Docket Number:	16-AAER-02
Project Title:	Appliance Efficiency Rulemaking for Computers, Computer Monitors, and Signage Displays
TN #:	214783
Document Title:	ITI -TechNet Comments on 15-Day Language for Computers, Computer Monitors, and Signage Displays
Description:	N/A
Filer:	System
Organization:	ITI-TechNet
Submitter Role:	Public
Submission Date:	12/13/2016 3:51:23 PM
Docketed Date:	12/13/2016

ITI -TechNet Comments on 15-Day Language for Computers, Computer Monitors, and Signage Displays (Docket #16-AAER-02)

**ITI/TechNet Comments on the Rulemaking (15-day language)
December 13, 2016**

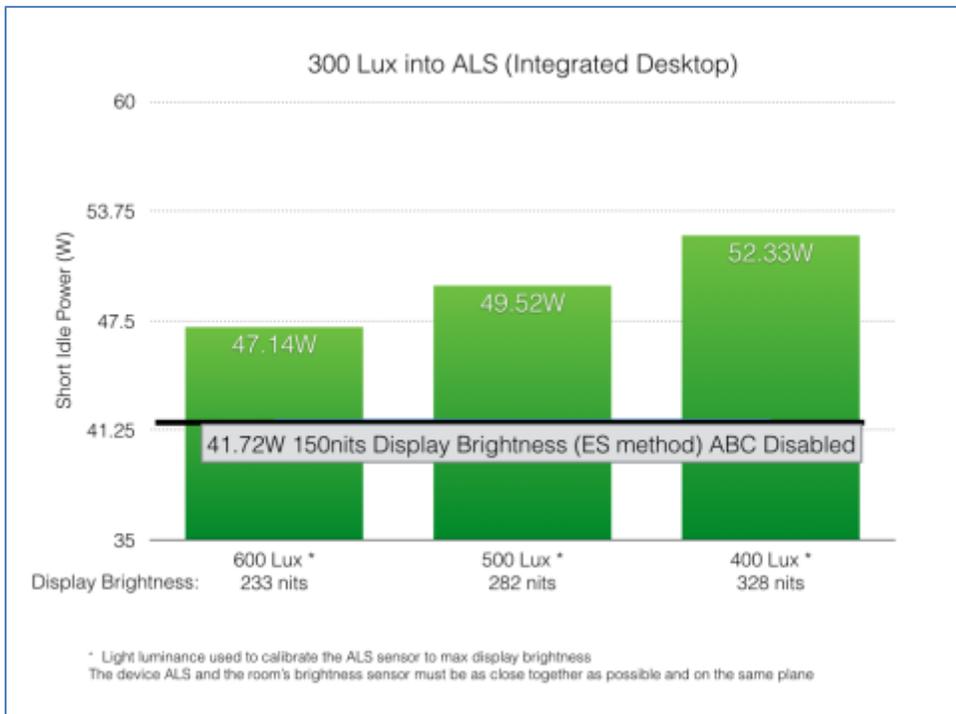
- Test labs would not know how to test products to get consistent results.
 - **Example 1: 2-in-1 Notebooks - ABC has two brightness settings**
 - Really low light = screen 102 NITs

- Above 70 lux = screen 300+ NITs

2-in-1 10.5"			2-in-1 12"		
	LUX	NIT	AC Pwr	LUX	NIT	AC Pwr
ABC disabled – fixed luminance	ES V6.1	91	5.6	ES V6.1	90	4.5
	0.1	99	5.6	0.1	99	4.5
	78	388	8.2	73	289	6.7
	97	387	8.2	102	289	6.7
ABC enabled	210	388	8.2	216	289	6.7
	310	388	8.2	310	289	6.7
	505	387	8.2	500	290	6.7

- **Recommendation:** Industry recommends that CEC abandons the proposal for testing systems with ABC supported and enabled by default. This will allow CEC standard to be globally harmonized with other PC standards.
